PLANNING COMMISSION MEETING AGENDA REGULAR MEETING

SUBJECT: PRELIMINARY SITE PLAN REVIEW (File Number SP JPLN2023-0014) -

Proposed Estates of Brook Hollow No. 2 Site Condominium, 3 units/lots, South of Lamb Road, East of Rochester (Parcels 88-20-14-351-104 and 88-20-14-376-047),

Preliminary Site Plan Approval for a Site Condominium Plan For City of Troy, Michigan

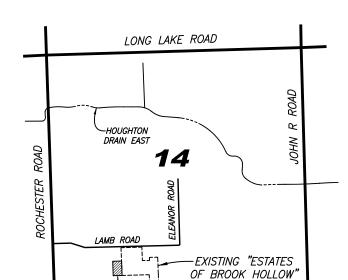
<u>Woodlands/Landmark Trees</u> – The applicant has identified a total of 15 trees on the site, or within grading area of the site. Of the 15 trees, 2 are regulated including two (2) landmark trees. The applicant is removing one (1) tree and providing 21 inches of new trees for mitigation. The Woodland Plan must be stamped by a certified landscape architect/ or arborist.

Landscape plan must be stamped by licensed landscape architect.

Items to be Addressed: Stamp landscape plan by licensed landscape architect.

- 1. Stamp landscape plan by licensed Landscape Architect.
- 2. Stamp tree survey by licensed Landscape Architect or certified Arborist.
